AGENDA

President and Board of Trustees
Village of Arlington Heights
Board Room

May 7, 2018

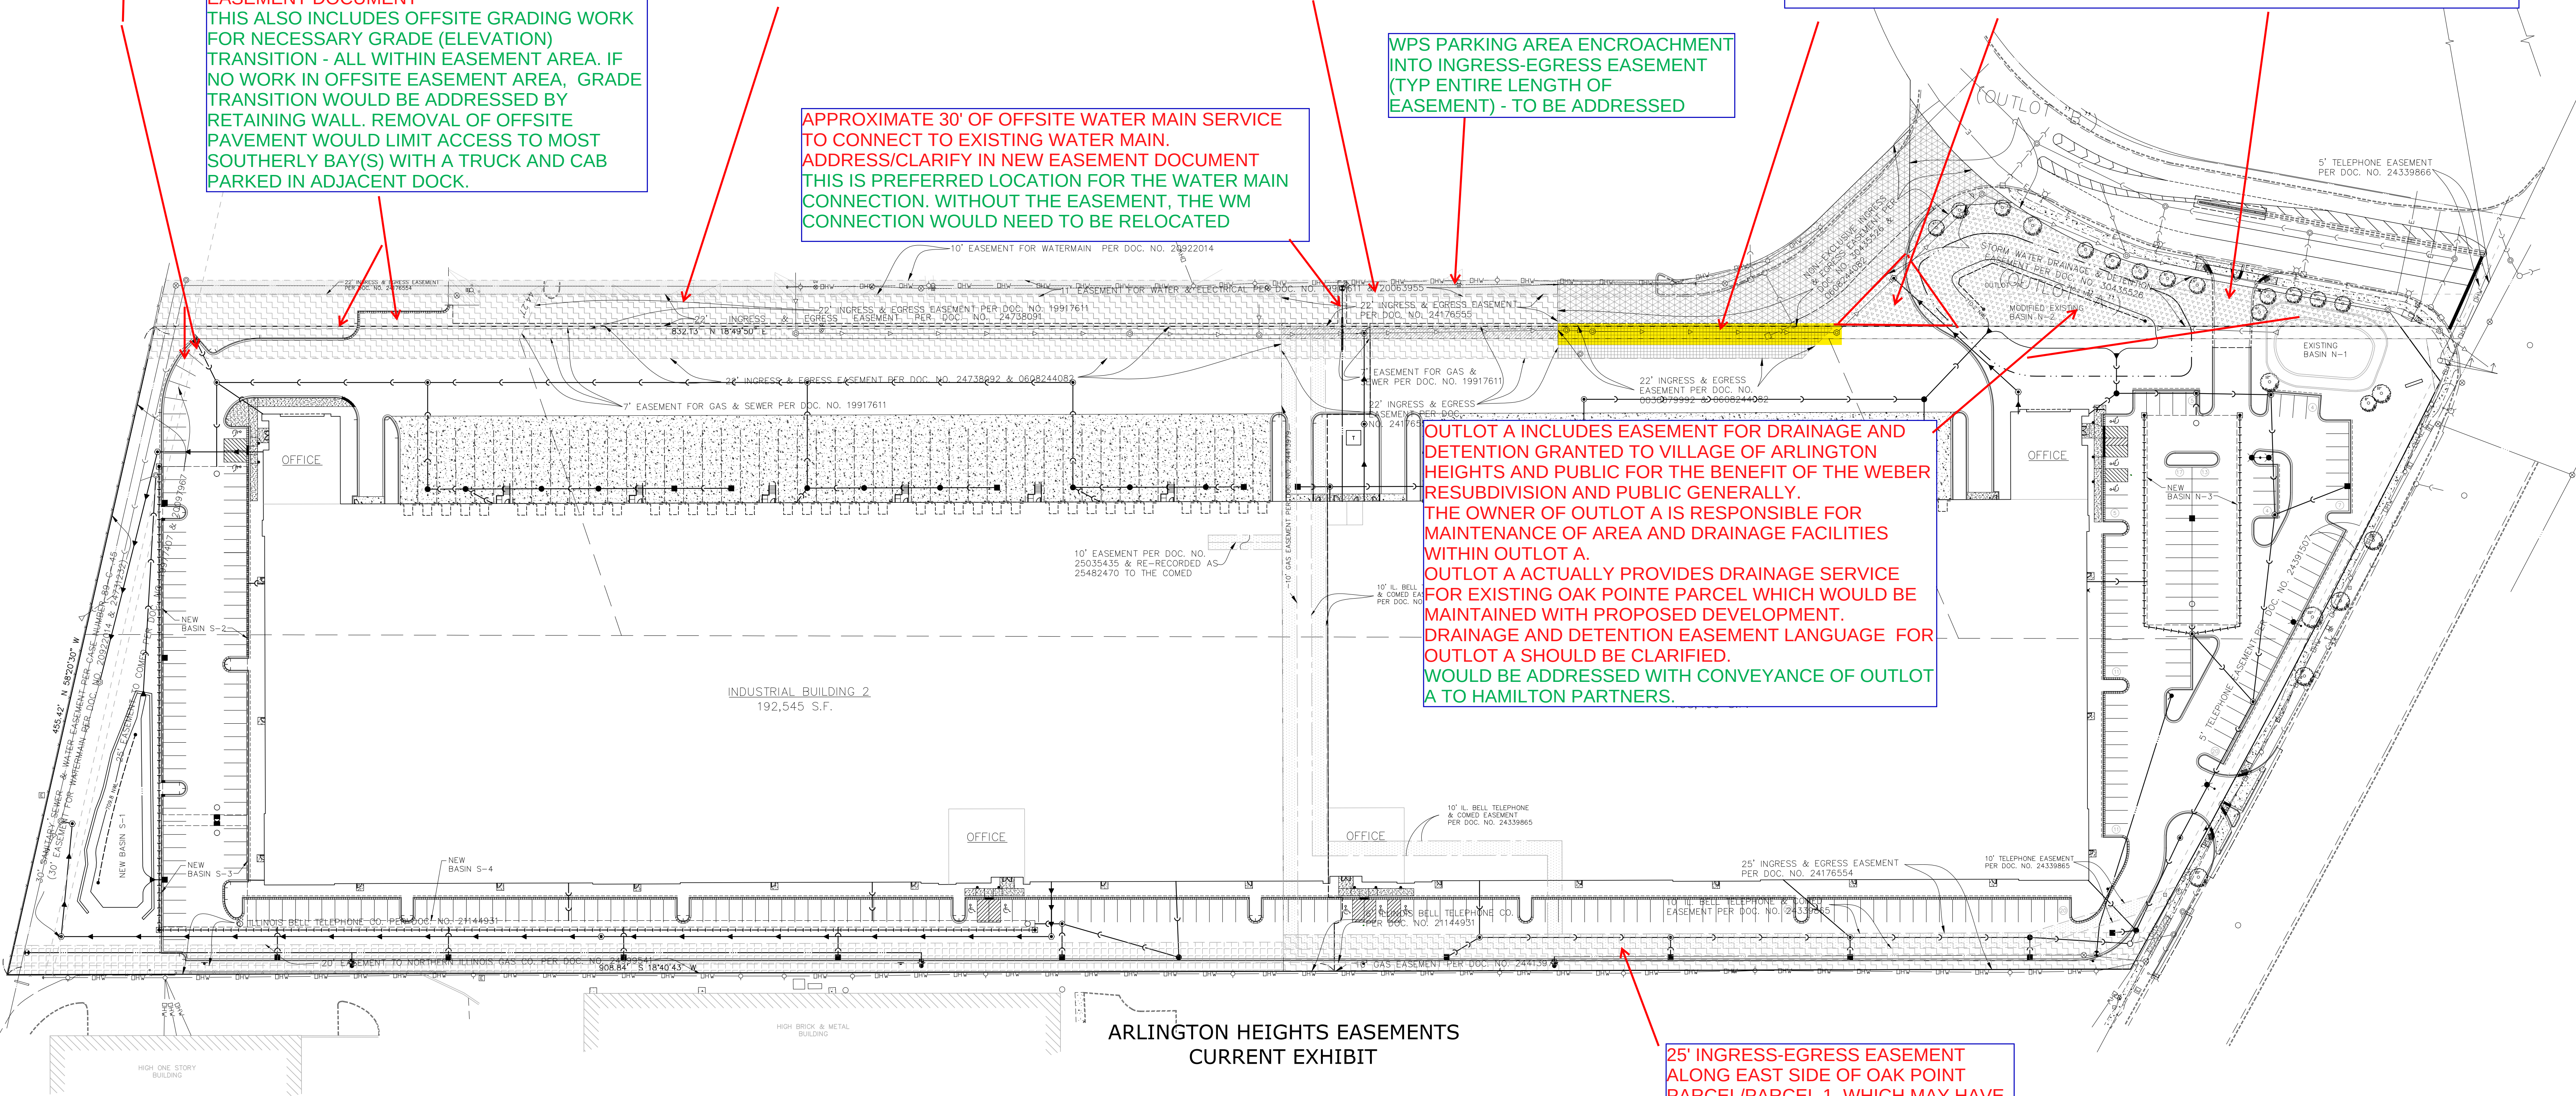
THERE ARE A NUMBER OF EASEMENTS ALONG THE COMMON DRIVEWAY GRANTED AT VARIOUS TIMES THRU THE YEARS, SOME OF WHICH HAVE BEEN VACATED OR PARTIALLY VACATED, RESULTING IN A COMPLEX SITUATION WHICH IS DIFFICULT TO FOLLOW. THE VILLAGE IS REQUESTING THIS SITUATION BE ADDRESSED/CLEANED-UP. IT IS SUGGESTED THE VARIOUS EXISTING EASEMENTS BE VACATED AND A NEW EASEMENT AGREEMENT (WITH PLAT/EXHIBIT CLARIFYING LOCATIONS) BE EXECUTED OUTLINING THE RIGHTS TO THE RESPECTIVE PARTIES ALONG THE COMMON DRIVE BASED ON CURRENT CONDITIONS. USE OF 22' EASEMENT ON WPS PARCEL ADDRESSED PER BRUCE GARNER'S MEMO OF MARCH 7, 2018

APPROXIMATE 30' OF OFFSITE WATER MAIN SERVICE TO CONNECT TO EXISTING WATER MAIN. ADDRESS/CLARIFY IN NEW EASEMENT DOCUMENT THIS IS PREFERRED LOCATION FOR THE WATER MAIN CONNECTION. WITHOUT THE EASEMENT, THE WM CONNECTION WOULD NEED TO BE RELOCATED

WPS PARKING AREA ENCROACHMENT INTO INGRESS-EGRESS EASEMENT (TYP ENTIRE LENGTH OF EASEMENT) - TO BE ADDRESSED

Figure: 5

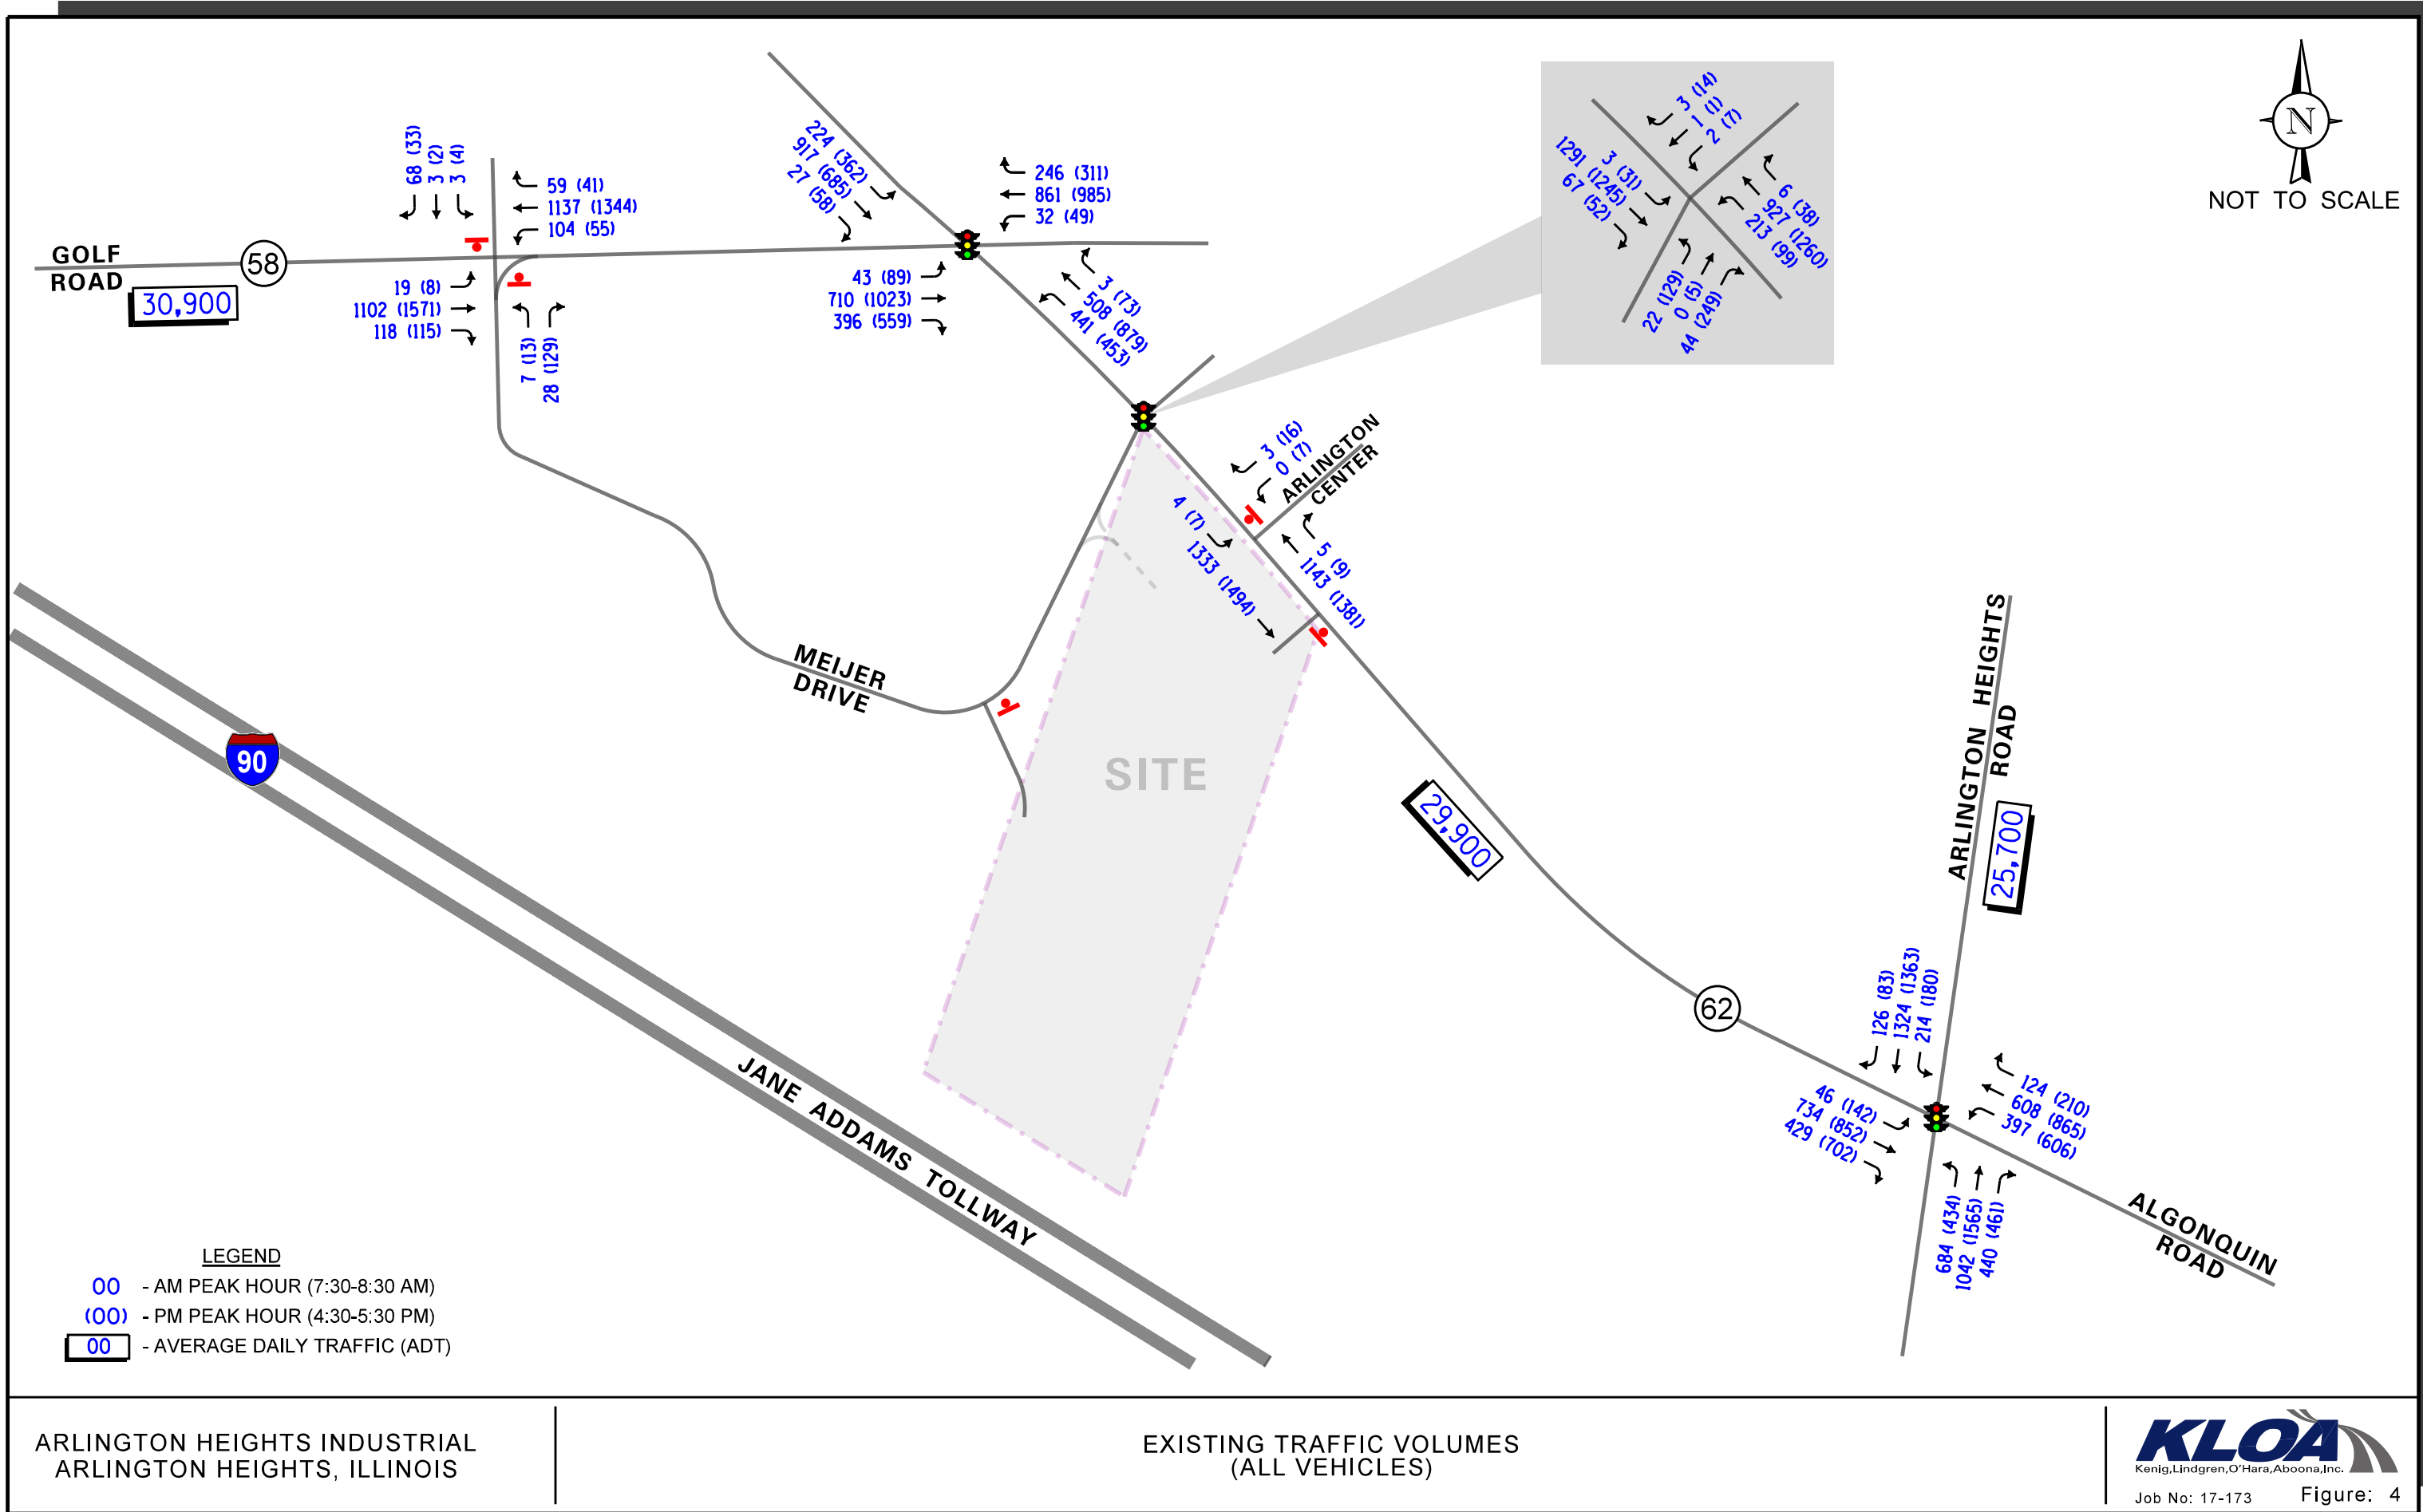
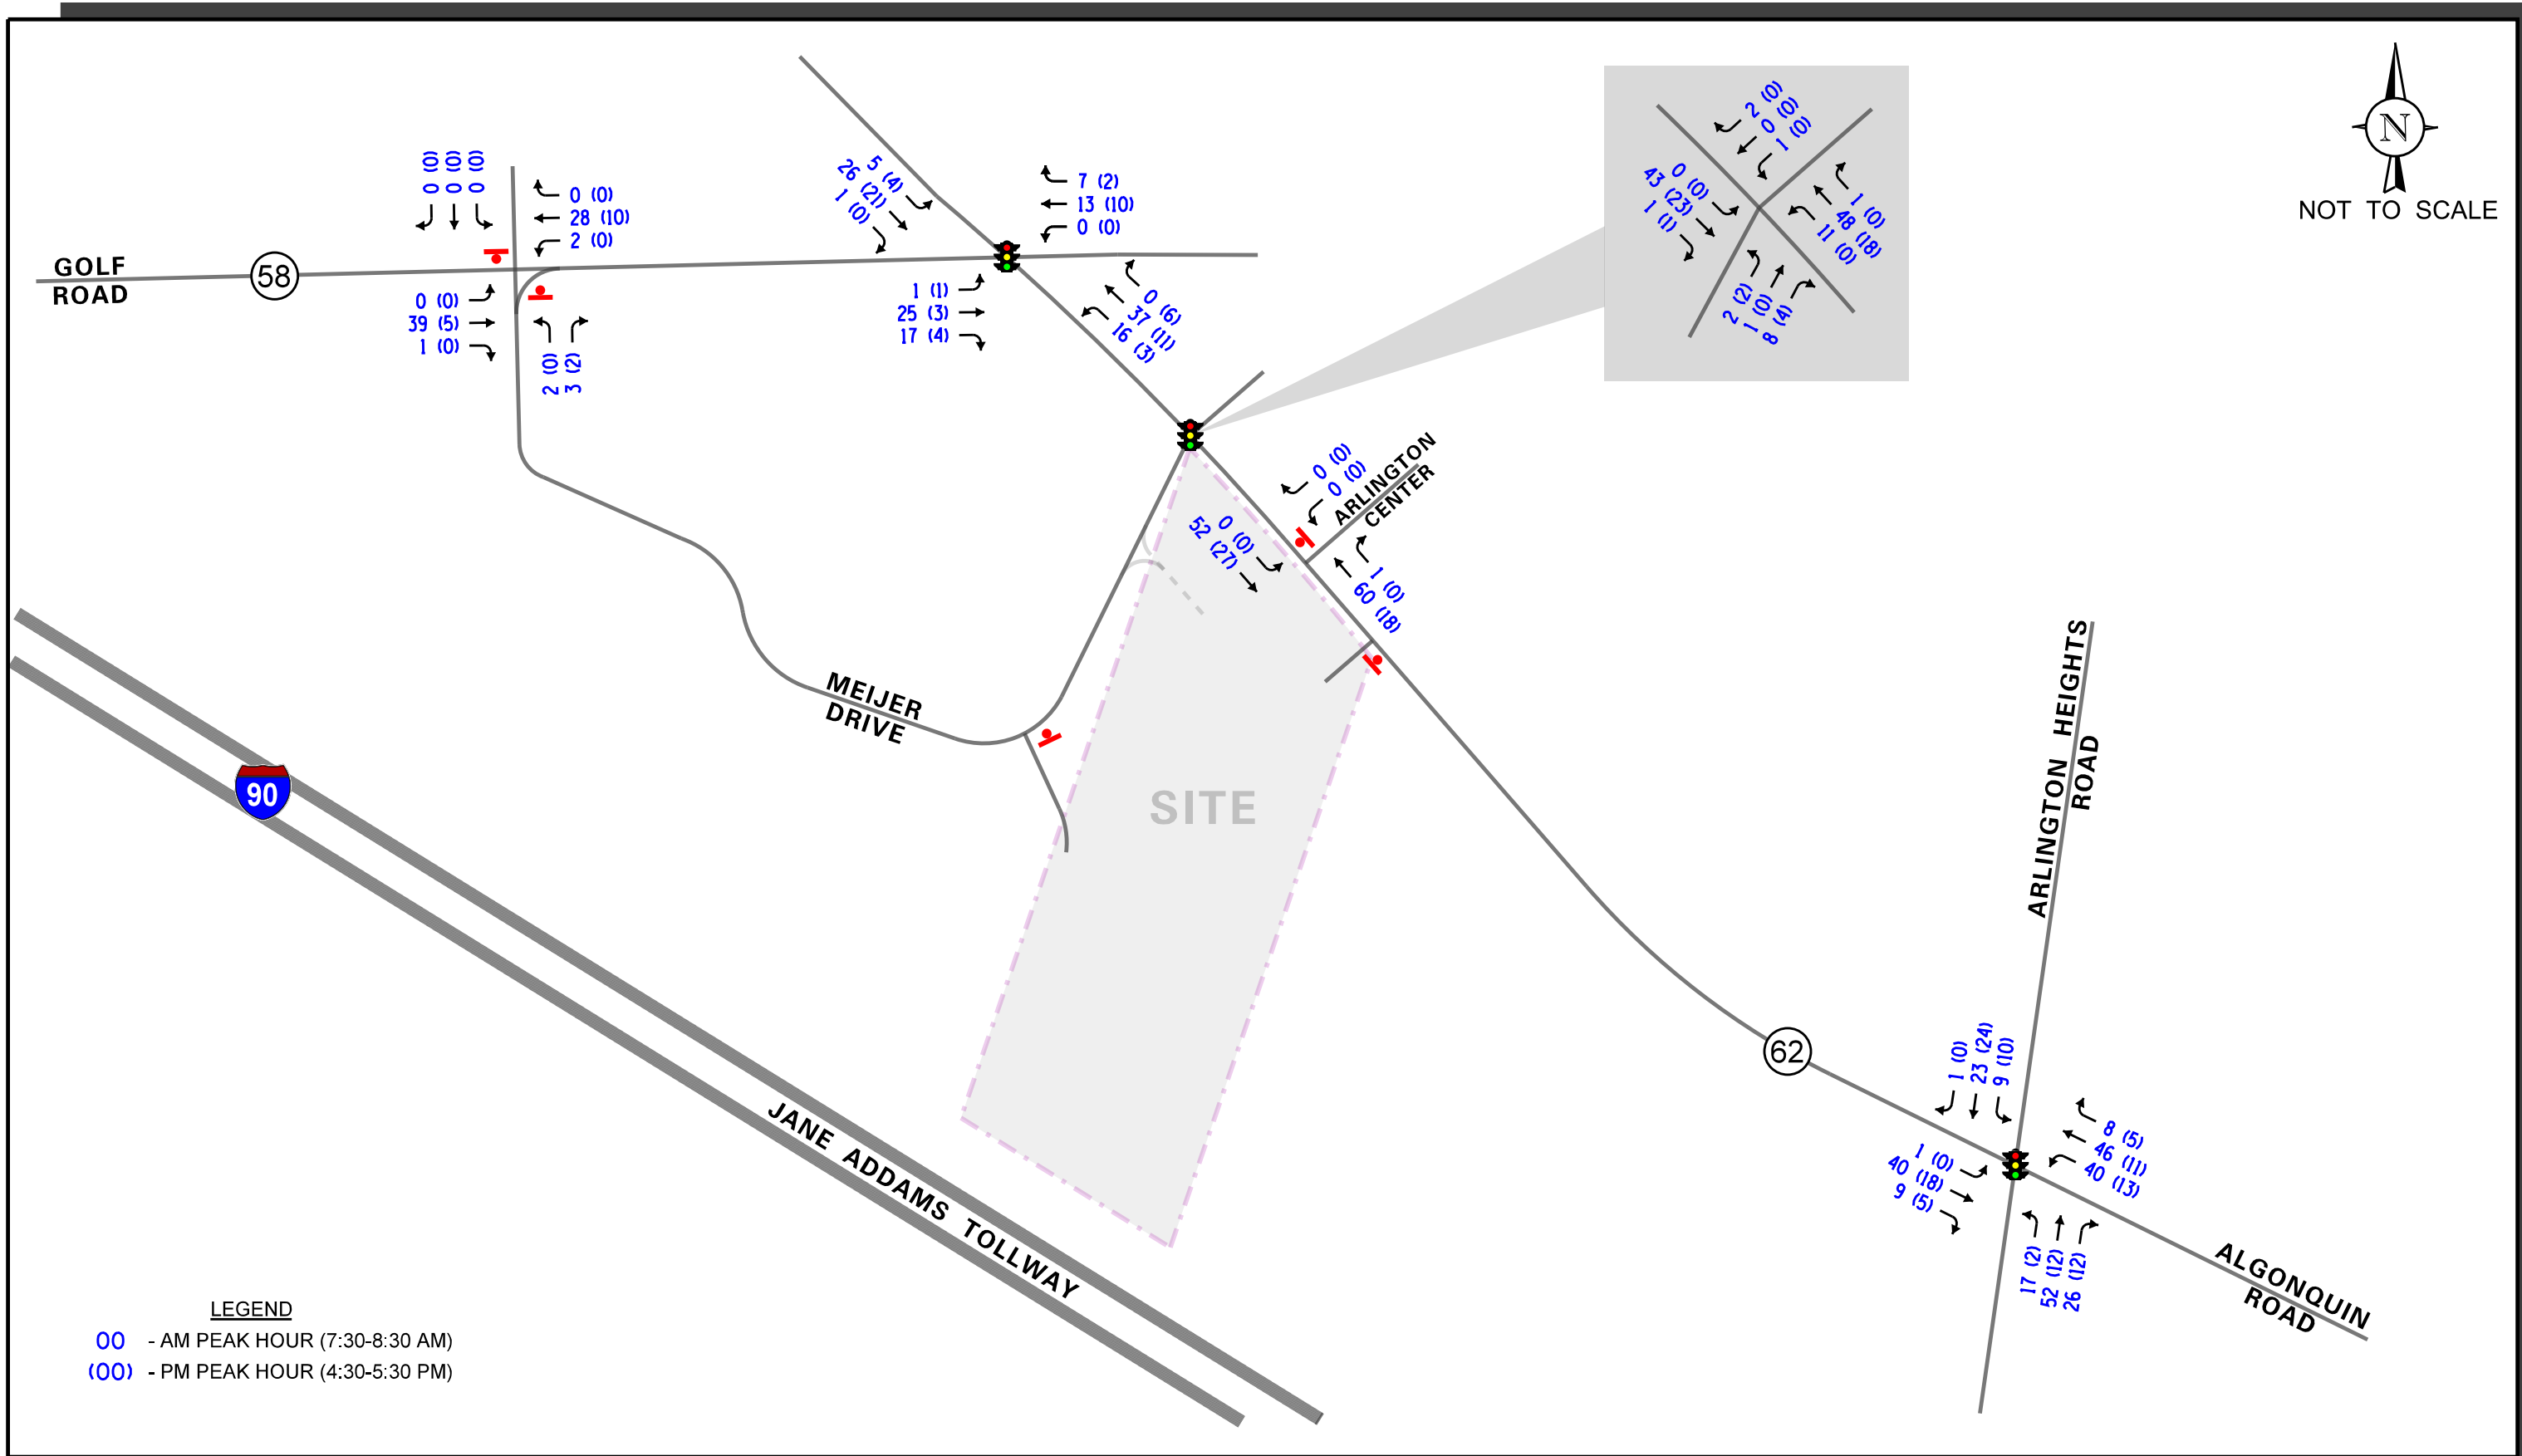
- 8) Please confirm, per figure 4 and 5 on pages 11 and 12 in the Traffic Impact Study, that there is currently no heavy truck traffic servicing the existing Oak Pointe property.
